LINCOLN-LANCASTER COUNTY HEALTH DEPARTMENT

SEWAGE INSTALLATION

GALEN WULF
T10N R7E SEC 14
LOT 60
9220 LEIGHTON STREET

REAL ESTATE TRANSFER/LOAN APPROVAL FORM

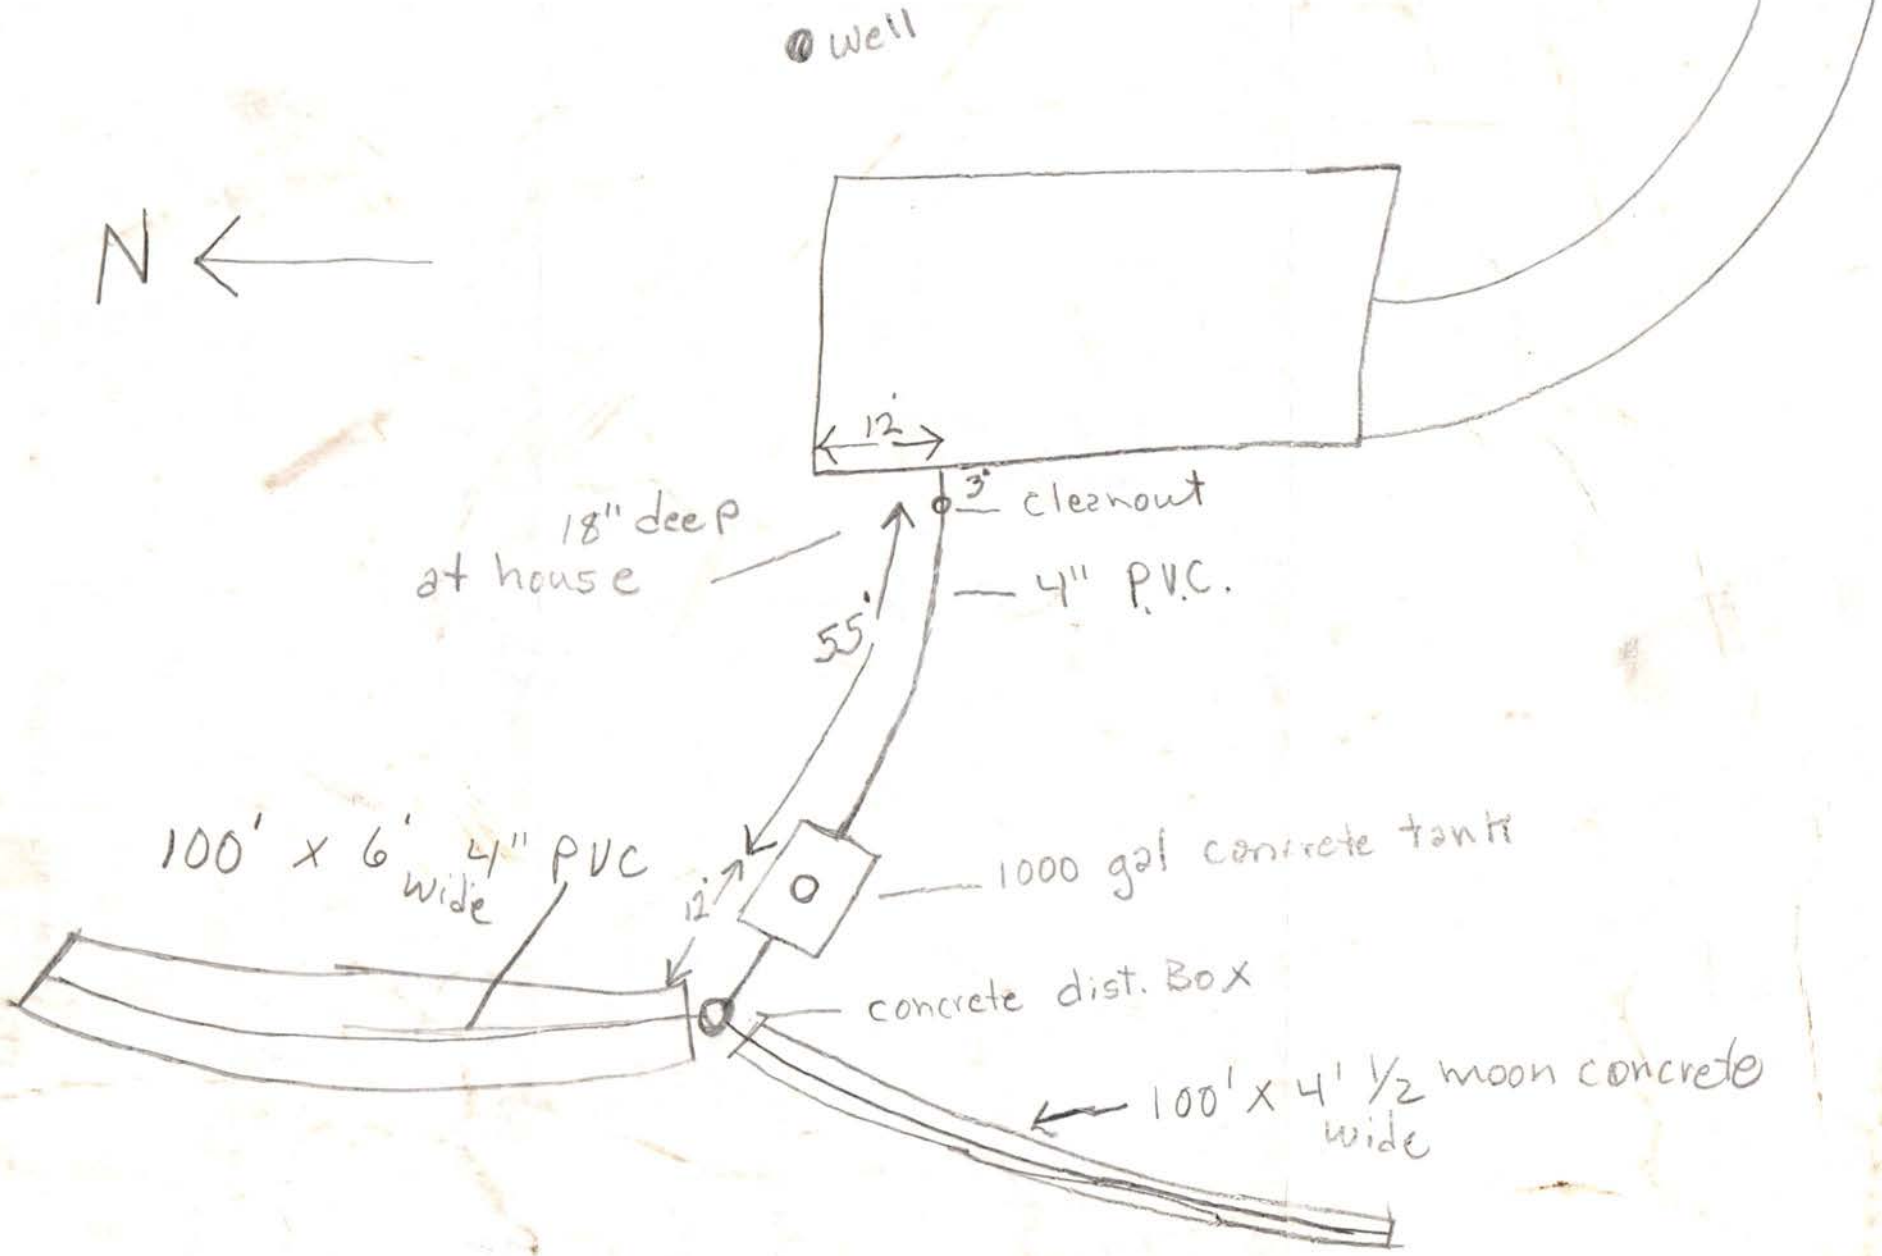
Comments: An experimental wider, shallow, seepage bed drain field was installed on this septic system. Thus, a provisional approval. There was no visible malfunction at the time of inspection. Recommend checking to see if septic tank needs pumping

WATER SYSTEM: Approved: ☒ **SEWAGE DISPOSAL SYSTEM** Approved: ☐ Provisional Approval: ☒
